### **IN THE DRAWINGS**

## **REMARKS**

Reconsideration and removal of the grounds for rejection are respectfully requested. Claims 1-8 were in the application, claims 9-10 have been withdrawn, claims 1, 2, 3 and 5-8 have been amended, and claims 11 and 12 have been added.

Claims 1 and 7 are not anticipated by Haisley. To begin, it is believed useful to review the operation of the applicants' invention. For reference, a version of Fig. 4, showing the liquid atomizer unit when in operation is depicted here.

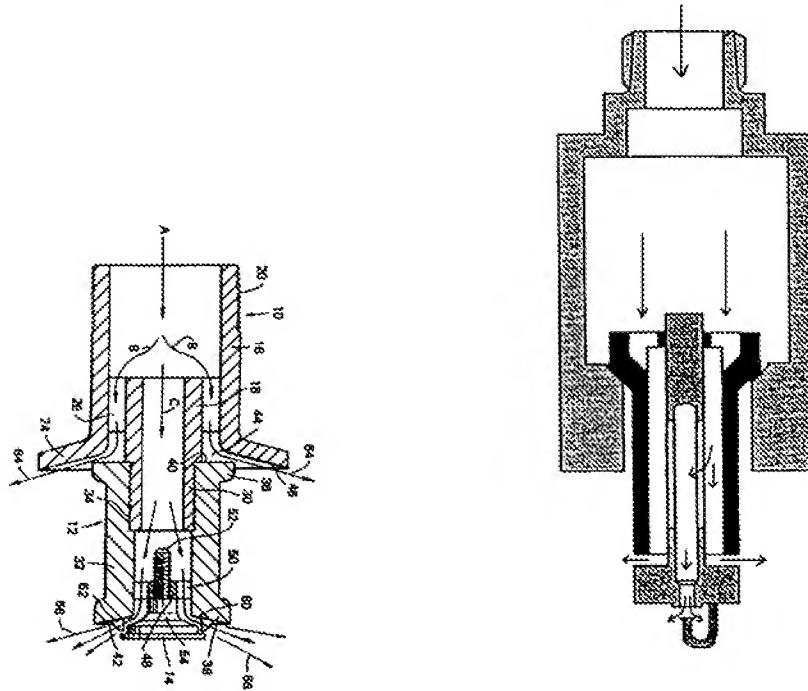
In operation, the unit moves down into sealing engagement with the nozzle housing so that liquid entering the housing is directed through the holes or gaps located on the bottom 2 of the cup. All of the liquid then passes into the cavity of the cup where it is split, some passing to the gap 14 for discharge in a full 360 degree circle, another portion passing through the side holes or slots in the mandrel, into the center hole 10 for discharge from the central hole 17. Note that the hole 17 is unobstructed so a full cone of liquid is developed. After exiting the hole 17, the liquid is disbursed by a baffle 18 located in front of the hole 17.

Note that the mandrel is attached at the bottom 2 to the cup and there are no obstructions or attachments to the cup in the cavity.

Comparing this to Haisley, there are several important differences. First, there is a diffuser 14 threaded into the opening 60 so the opening is "partially

blocked" (abstract), as opposed to the full opening of applicants' central hole 17. The elements 50 also break the flow by the opening, so that a full 360 degree spread is not assured. No such elements are found in the applicants' device, because the mandrel attaches at the bottom 2. Further, there are no side slots or holes shown leading to the opening. As to the annular opening 44, the flow is similarly divided because of the elements 26 being located near the exit. Note that there is no perforated element at the entry corresponding to the bottom 2 of the applicants' invention.

Moreover, these differences are important, leading to significant advantages. The mounting of the mandrel to the bottom allows full 360 degree liquid flow at the liquid exit 14, yielding better atomization and even distribution. The placement of a baffle face 18 in front of the hole 17 also provides more uniform distribution directly under the unit, as opposed to the Haisley unit where radial distribution is predominant.
